Kimball Woods Subdivision

Concept Plan for Remainder of Parcel

Eastern Connecticut Environmental Review Team Report

Report #617

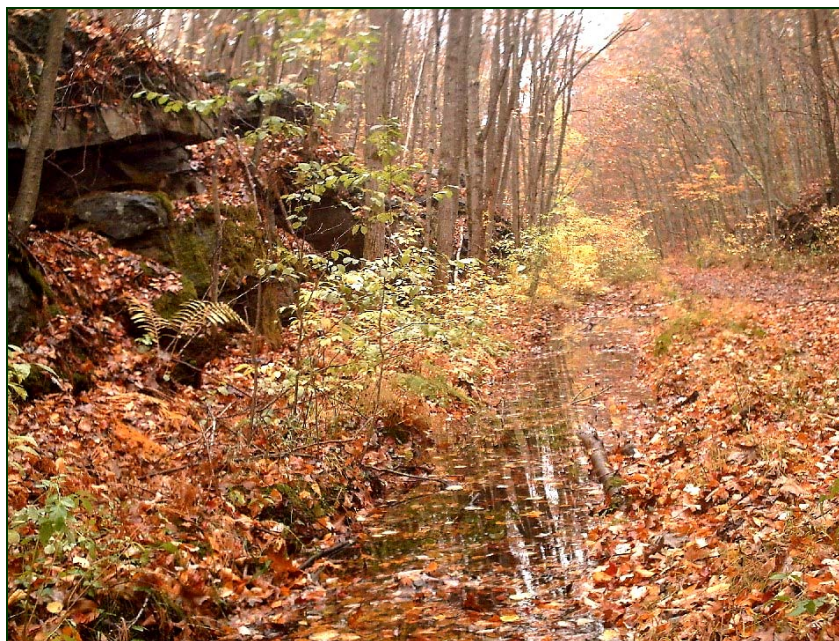
The stump in the foreground is the result of a tree having been cut within the bounds of the flagged hillside wetland. The draped wetland flag is easily visible on the tree “above” the stump.

The white line in the photo above indicates the approximate continuation of the wetland boundary towards the viewpoint.

In the photograph below the tree above is clearly marked with a wetland flag yet the refuse of the wood cutting operation remains on the landscape, both inside and outside of the flagged wetland boundary.

Trees were felled into, and subsequently left within, the flagged wetland on the hillside.

Post ERT meeting discussion among members revealed that within the wetlands and the wetland review areas, trees were NOT to be cut and logging refuse left. Thus, Chaplin will have to take steps to ensure this type of unsupervised activity no longer takes place and that it is not an indication of future performance. The town must find a way to ensure that plans are kept within ‘as-built’ specifications and agreements. Perhaps the town can incorporate into their zoning laws a provision for applicant to pay for a mutually agreed upon investigator to review and report to the town at agreed upon intervals (once, twice a day/week etc.).
